RE: DEPN-23-0157

We are writing to provide feedback on the proposed Major Modification of the Wilson Tank Replacement project (Record number DEPN-23-0157).

Figure 1 – Elevation of Tank Height (Page 12, AR DP 21-00526)

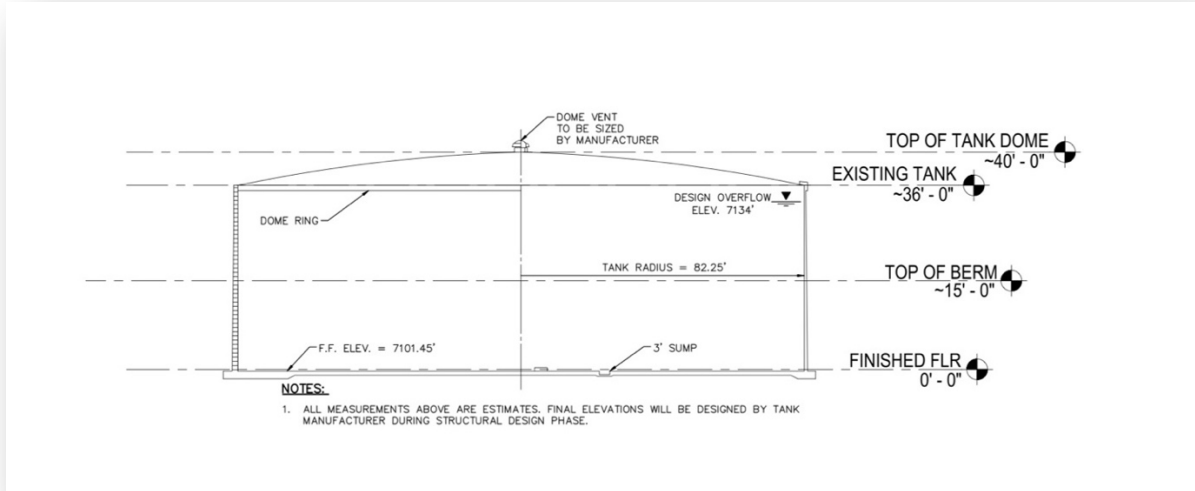
Correspondences and other documents on record for AR DP 21-00526 refer to minimizing the height of the replacement tank to be similar to the existing tank. The geological report lists the height of the existing tank as 32.5 feet (measured). An elevation (see Figure 1) from the approved plan has the replacement tank's height as 36-foot walls with a 4-foot dome for a total of 40 feet. Additionally, the approved engineering drawings has a maximum height "per code" of 45 feet (see Figure 2). The proposed modification (DEPN-23-0157) lists the height as approximately 60 feet. Currently, the tank is under construction and the height of 60 feet is now the as-built height. Depending on one's starting point, the as-built tank is between 48% and 82% higher than plan specifications and expectations. The fact the as-built tank is almost twice the height of the existing tank represents CSU's gross disregard for 1) the surrounding neighborhood and 2) Planning's procedures/processes. We consider constructing the as-built tank at its current height is unconscionable and cannot excuse the misinformation promulgated by CSU and their subcontractors.

Figure 3 – Development Plan Approval Process §7.5.515.C

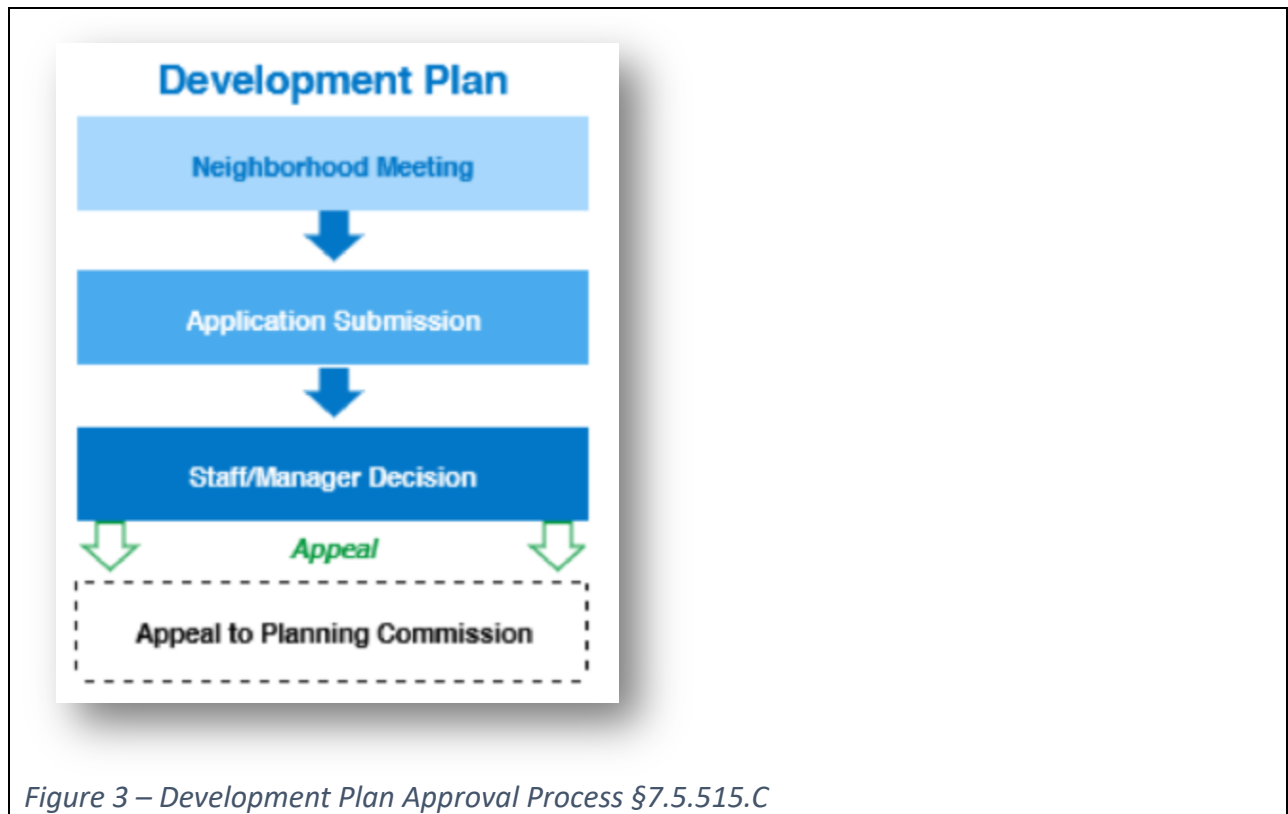
4. UDC §7.5.402.B states that *a neighborhood meeting may be required for development plans*. It refers to table 7.5.1-A which shows that a neighborhood meeting prior to submission is a Manager's decision but is an important process step of the approval flow (see Figure 3). However, a major project with the significant impact as this one begs to make it a requirement to hold a meeting; perhaps the current predicament could have been avoided. CSU has not had any neighborhood meeting focused on the Wilson Tank Replacement. The first application was made under the retired Chapter 7 (and during the COVID pandemic) and any neighborhood meeting appears to have been optional. The proposed Modification, covered under the current UDC, should require a meeting (see Figure 3). Although CSU conducted a meeting on 7/26/23, the agenda focused on landscaping and colors options for the tank. Another meeting is planned for 8/10/23 to continue this discussion. There have been no meetings with the neighborhood to discuss the amendment although the amendment was submitted on 7/18/23.

**Requested Action:** Revoke approval of AR DP 21-00526 and require CSU to follow UDC procedure 7.5.516.B.2 and resubmit the entire plan for the required review.
